SERVICE BULLETIN

NACELLE - POWER PLANT - CLIPPING POINTS, CORE FIRE SERVICES HARNESS - MODIFICATION OF
- CATEGORY CODE 4 - MOD.NAC-71-00111. Planning InformationA. Effectivity

- (1) Airplane: Airbus A320
- (2) Nacelle: V2500-A1 Nacelles

V2500-NAC-71-0011

Location of Engine Core Harness Assembly Clipping Points
 Fig.1

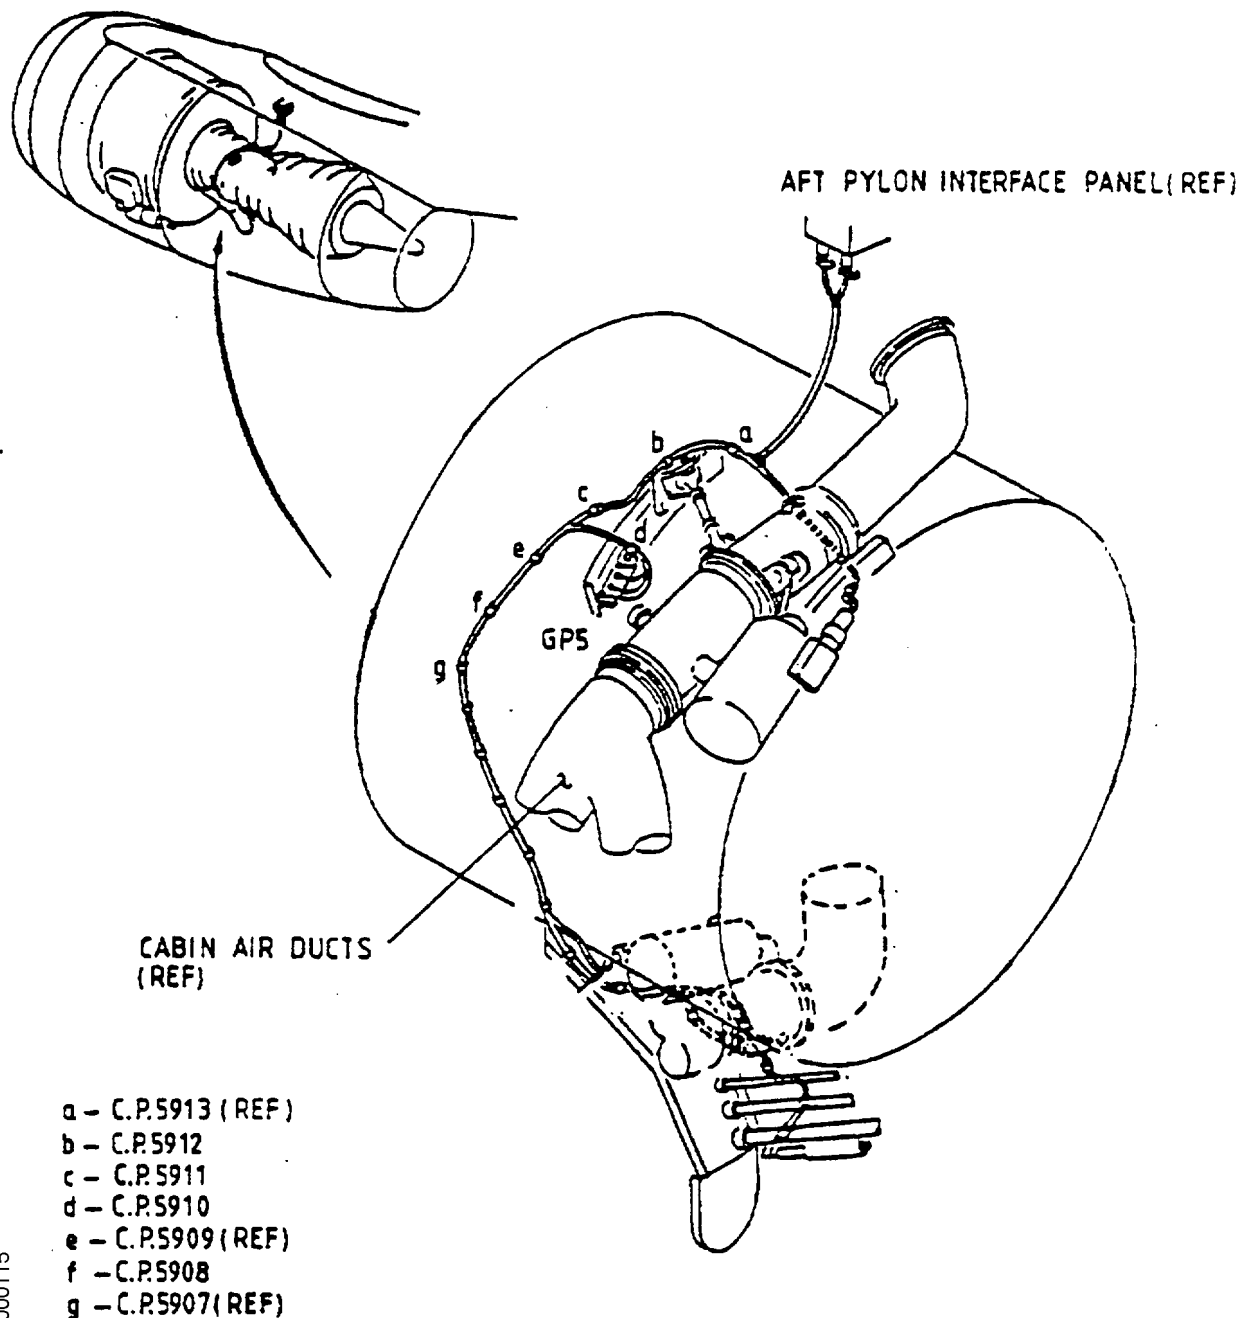
- (1) Open the thrust reverser halves as specified in the V2500 Aircraft Maintenance Manual, Task 78-32-00-010-010.
- (2) Find the GP5 ground point on the left side of the engine core at PPS 117.90. (Refer to Figure 1.)

- (1) Remove an AS21407 bolt, an AS20624 nut, a SP154-D washer, and a TA027000-PH-07-WC 'P' clip from clipping point CP5912. Discard the bolt, nut, washer, and 'P' clip. (Refer to Figures 1 and 2.)

Before and after Views of the Clipping Point Changes to the Engine Core Harness Assembly
Fig.2

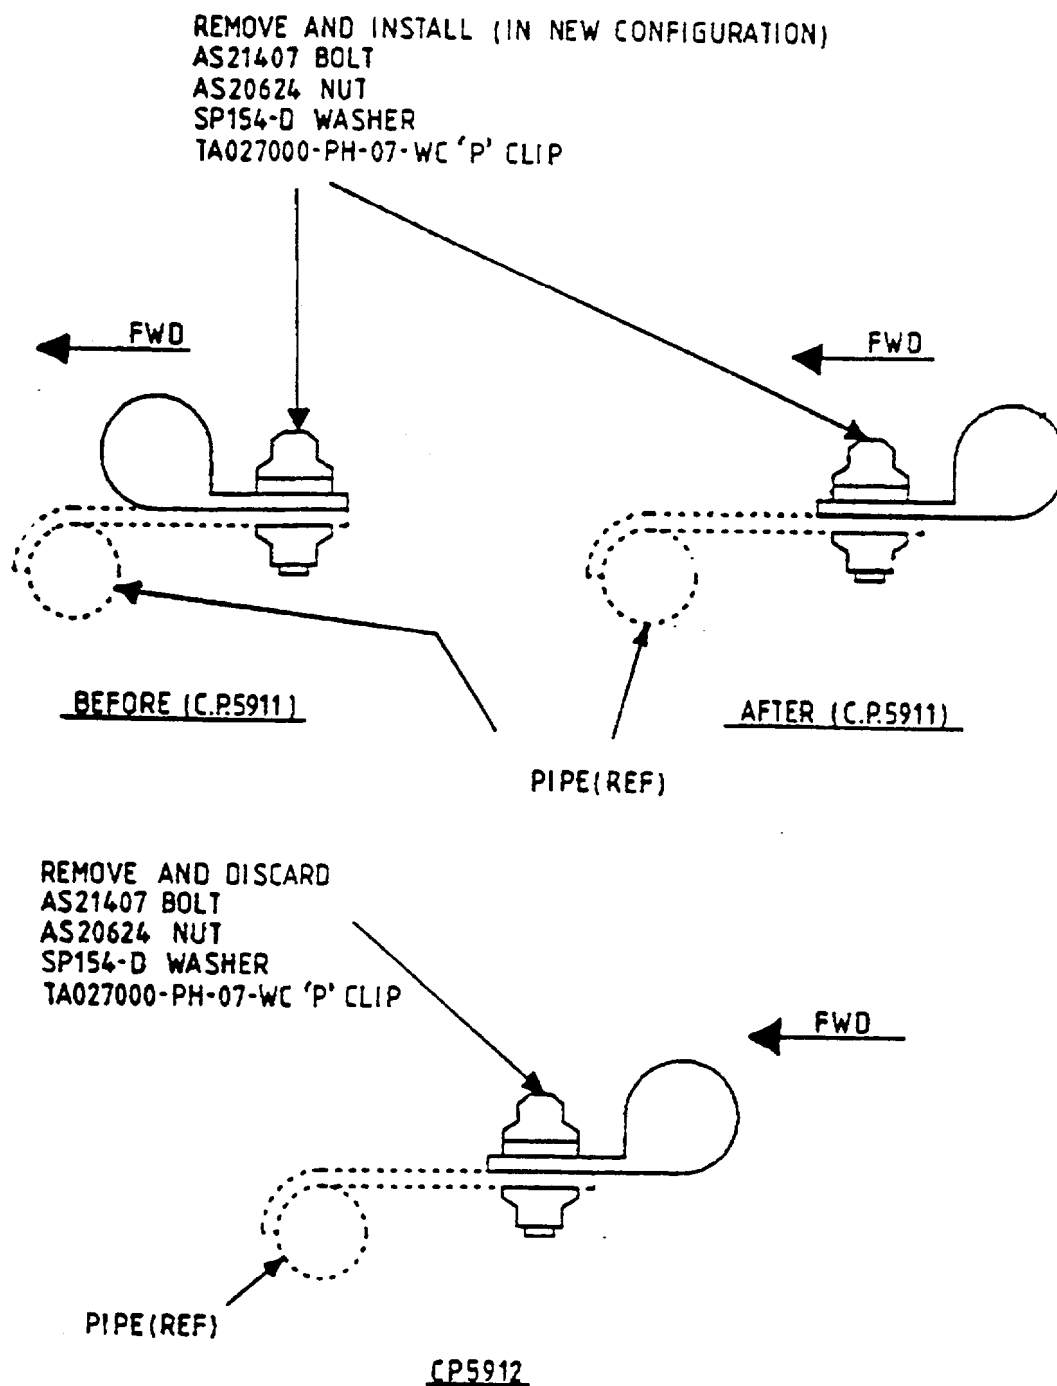
Clipping point 5912 is removed and discarded. Clipping points 5911 and 5908 are adjusted (refer to Figures 2 and 3) and a spacer is installed at clipping point 5910. (Refer to Figure 3.) These changes will increase the clearance between the core fire services harness and the hot air pipe. Also it will give clearance between the harness and the engine support to prevent damage to the harness while in transit.

- (2) Remove an AS21407 bolt, an AS20624 nut, a SP154-D washer, and a TA027000-PH-07-WC 'P' clip from clipping point CP5911. Keep the bolt, nut, washer, and 'P' clip.

- (6) Install the AS21407 bolt, AS20624 nut, SP154-D washer, and the TA027000-PH-07-WC 'P' clip (in the new configuration) to clipping point CP5908. Torque the bolt to 40 lb-in. (4.25 N.m). (Refer to Figure 3.)
- (7) Install the AS21407 bolt, AS20624 nut, SP154-D washer, and the TA027000-PH-07-WC 'P' clip (in the new configuration) to clipping point CP5911. (Refer to Figure 2.) Torque the bolt to 40 lb-in. (4.52 N.m).

Before and after Views of the Clipping Point Changes to the Engine Core Harness Assembly
Fig.3

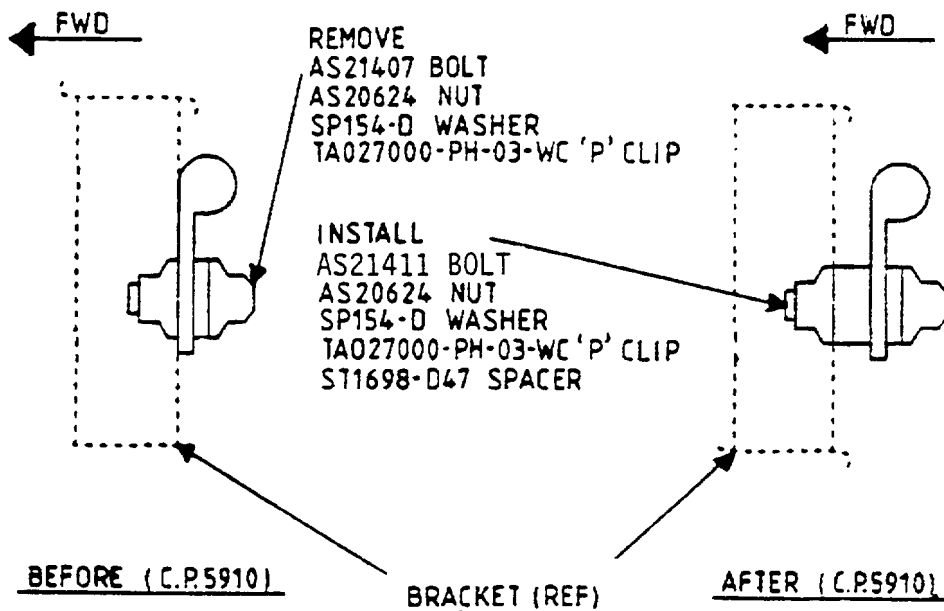
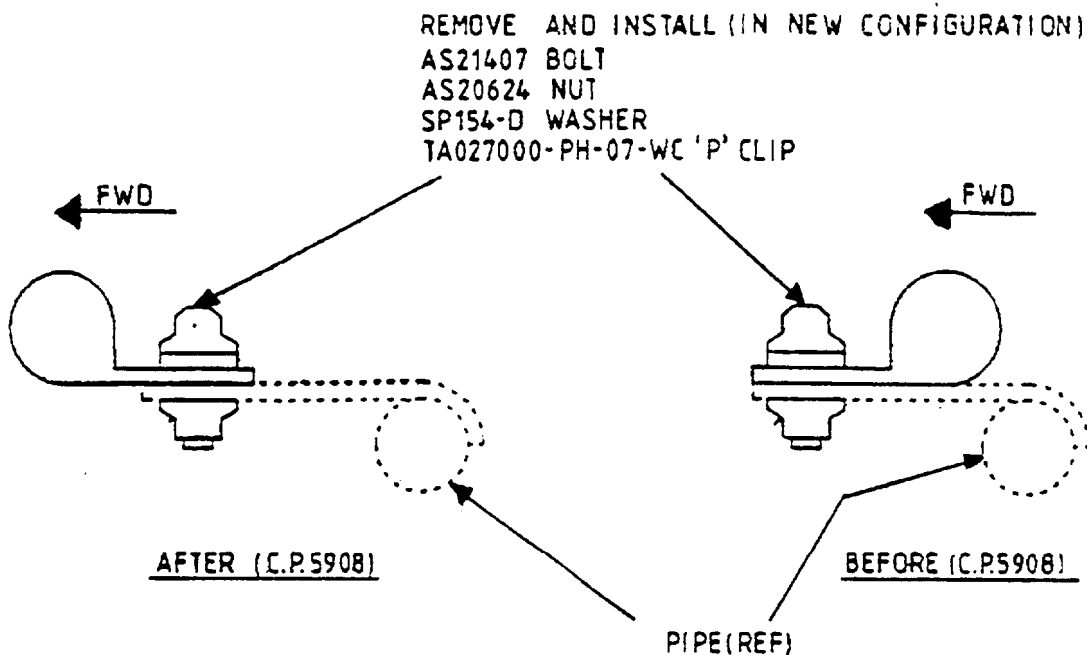
- (3) Remove an AS21407 bolt, an AS20624 nut, a SP154-D washer, and a TA027000-PH-07-WC 'P' clip from clipping point CP5908. Keep the bolt, nut, washer, and 'P' clip. (Refer to Figures 1 and 3.)

- (4) Remove an AS21407 bolt, an AS20624 nut, a SP154-D washer, and a TA027000-PH-03-WC 'P' clip from clipping point CP5910. Keep the bolt, nut, washer, and 'P' clip.

- (5) Install the AS21411 bolt, AS20624 nut, a SP154-D washer, TA027000-PH-03-WC 'P' clip and a ST1698-D47 spacer to clipping point CP5910. (Refer to Figure 3.) Torque the bolt to 40 lb-in. (4.52 N.m).
